APPENDIX 7: COMMENTS AND RESPONSES ON PROPOSED 2016 MONITORING NETWORK PLAN, REVISION 1

Re: 2016 Monitoring Network Plan, Revision 1 (November 15, 2016)

Figure 18. Top 300 receptors based on 2013-2015 data.

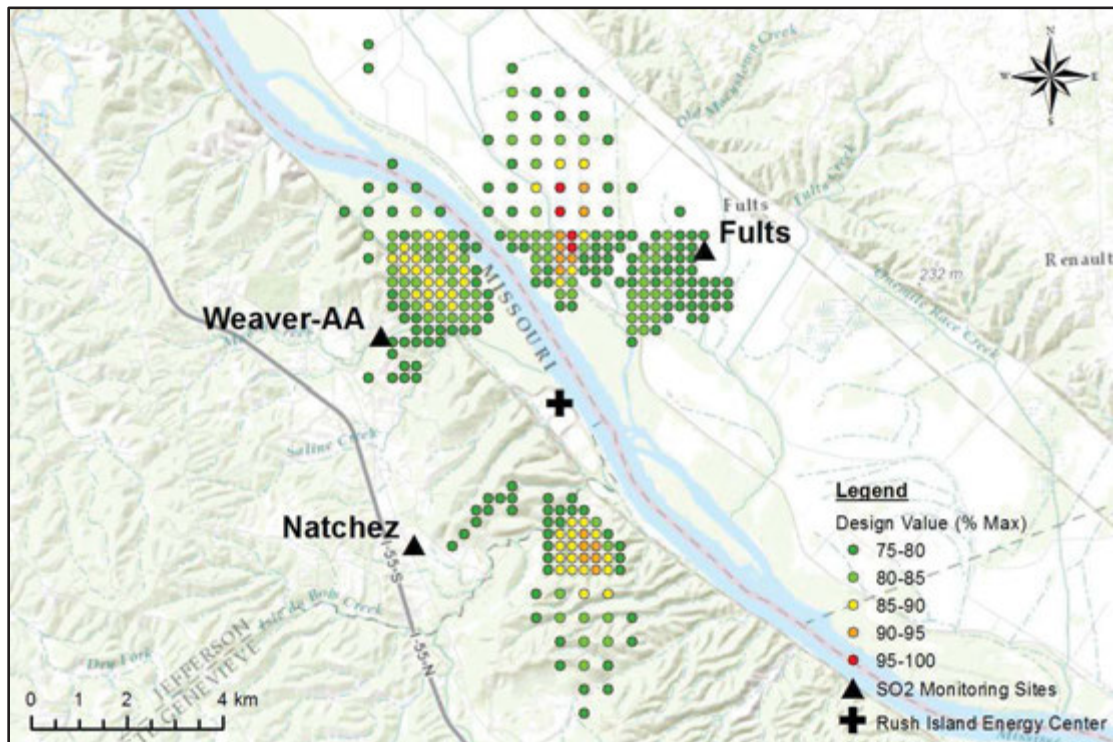
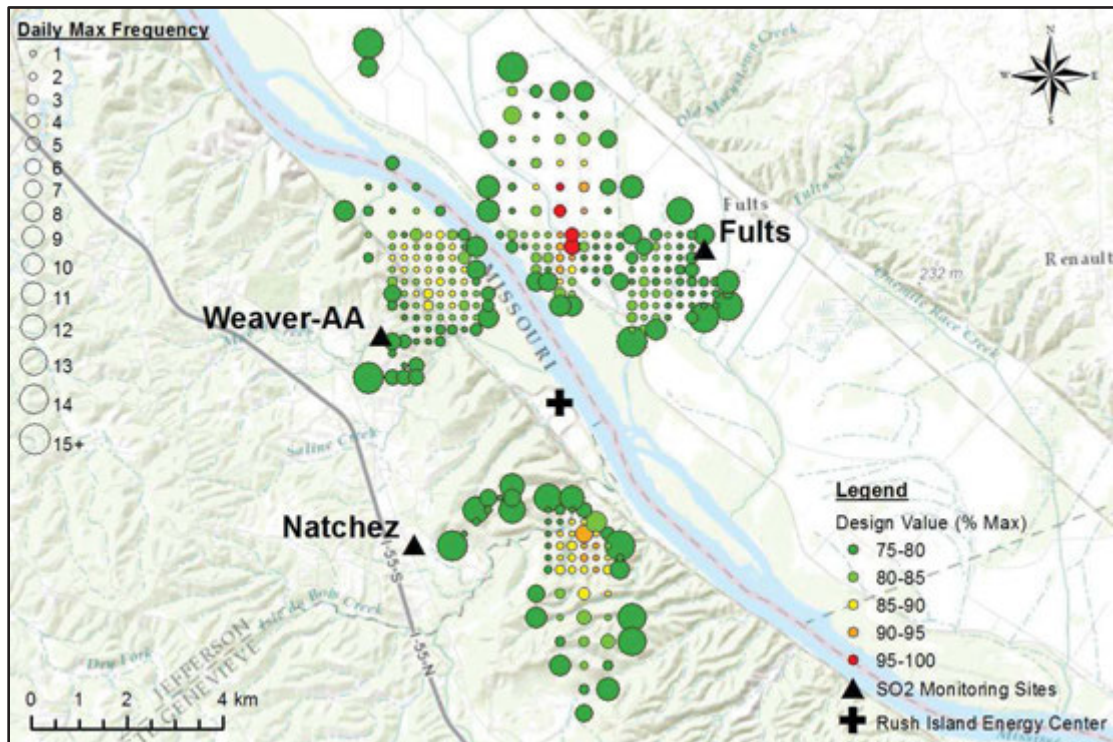
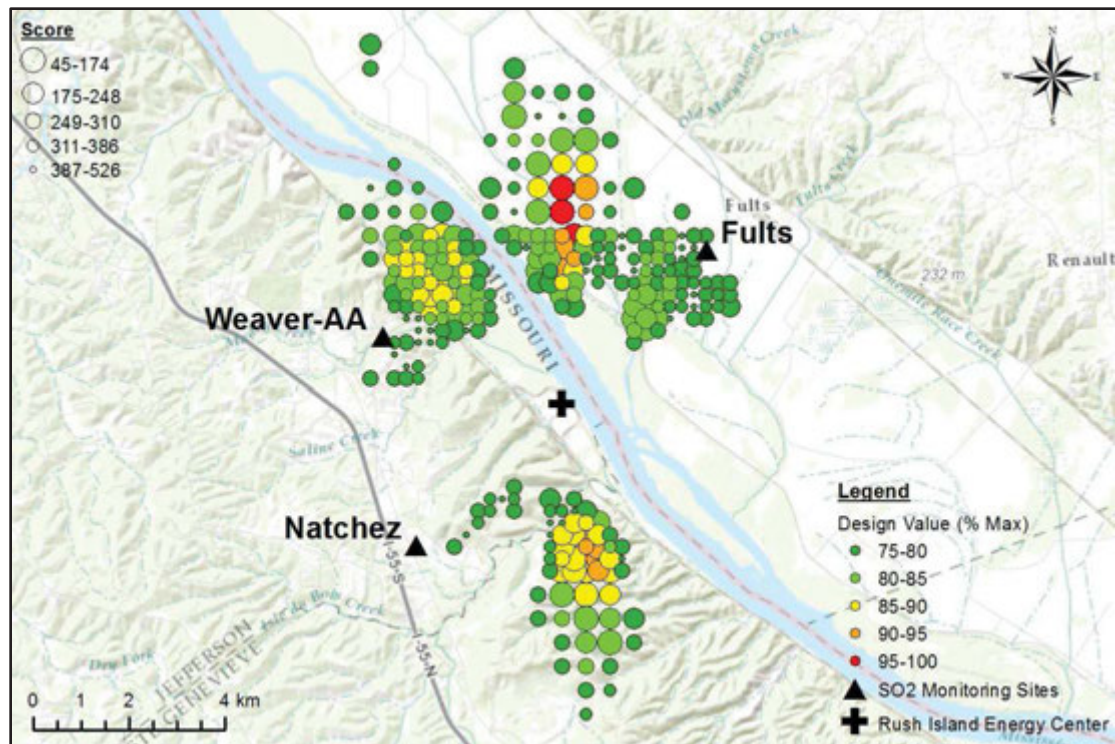
Updating DNR’s modeling to use 2013-2015 emissions and meteorological data results in markedly different results from those obtained using 2011-2013 data. Figure 18 shows the 300 receptors with the highest modeled design values when 2013-2015 data are used; Figure 19 shows the frequency of having the highest 1-hour daily maximum concentration among these receptors; and Figure 20 shows their scores, which were calculated by adding their respective concentration ranks and day ranks per the scoring strategy described in the TAD.

Figure 21. Receptors with the 10, 25, 50, and 100 highest score ranks (clockwise from upper left) based on 2013-2015 data

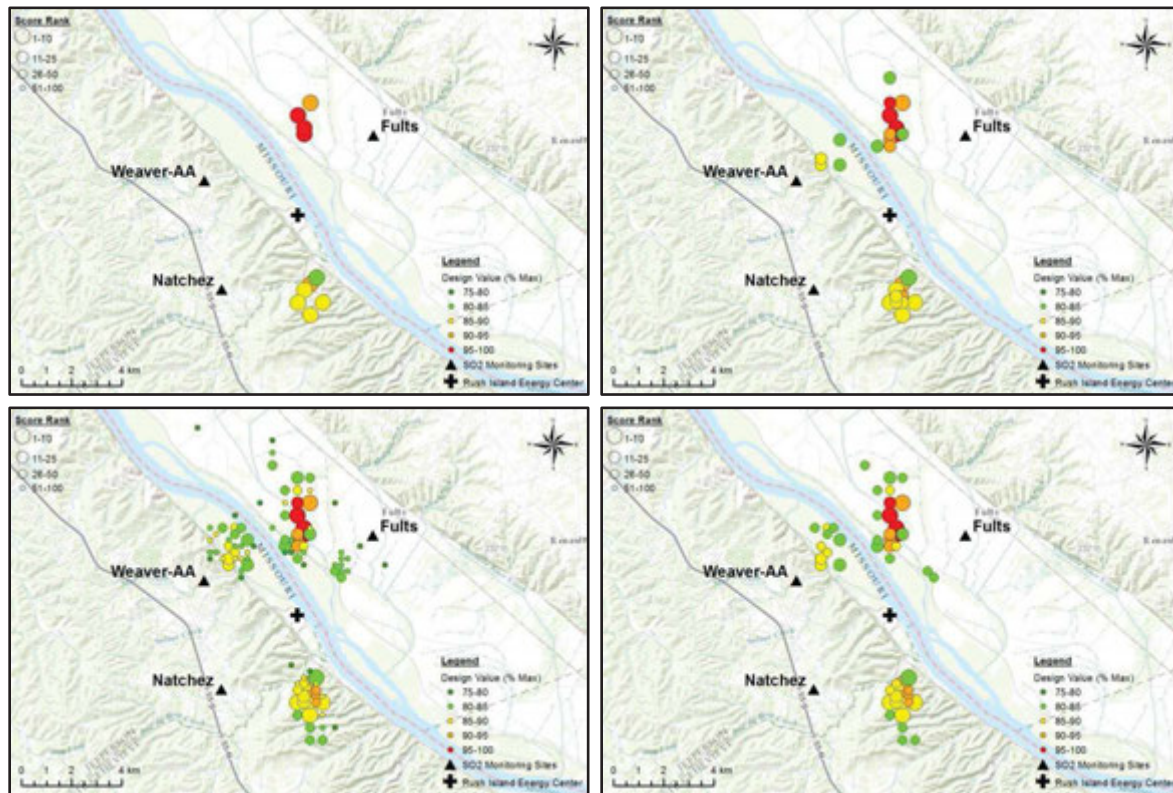
When 2013-2015 data are used, the highest concentration areas shift and are located immediately north and south of the plant instead of to the east, northeast, and northwest, as shown in Figure 18. The receptors with the lowest scores – i.e., those with the highest combined concentration rank (based on modeled design value) and day rank (based on frequency of having the highest 1-hour daily maximum concentration) – are similarly located north and south of the plant, as shown in Figure 20. Furthermore, when the top receptors are ranked by score so as to provide a list ranked in general order of desirability with regard to siting monitors in accordance with the Monitoring TAD, there are no high-ranking receptors near any of the existing monitors. Figure 21 shows the 10, 25, 50, and 100 receptors with the highest score ranks based on modeling using 2013-2015 data.
